2. Do you have any comments on our proposed green bridge?

Concrete Bridge above

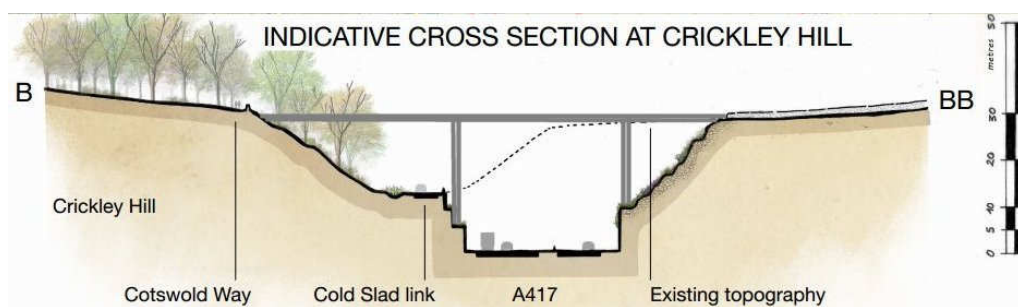
This image illustrates the height of the proposed concrete bridge. A layer of vegetation on the top allows it to be referred to as a Green Bridge.

The currently proposed “green” bridge appears to be concrete with grass on a flat surface, compared to other green bridges being constructed countrywide on current road projects (see note on Green bridges and note on A27)
Can it really be said to be a good fit within the landscape of the Cotswolds AONB?

It would be preferable for a green bridge if suitably located to have green flanks and mixed native vegetation along the sides rather than concrete pillars.

Green Flanked Bridge

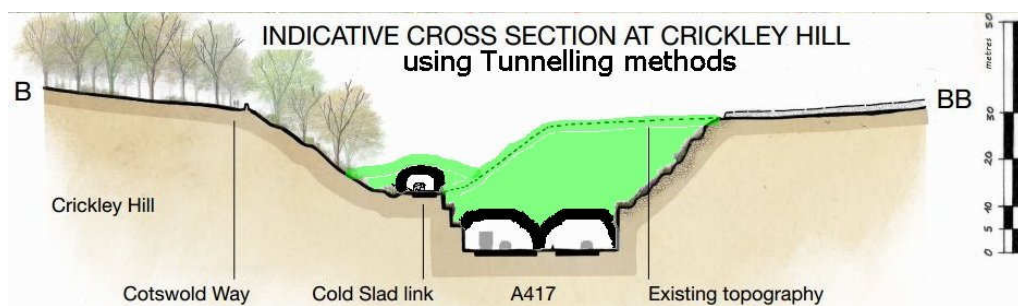
Green 'flanked' bridges could be installed instead. A standard inverted U bridge as used in the Dorset AONB could cover the minor Cold Slad link road (the current A417). A tunnelling method similar to Hindhead could be used for the new A417 to retain the existing topography.
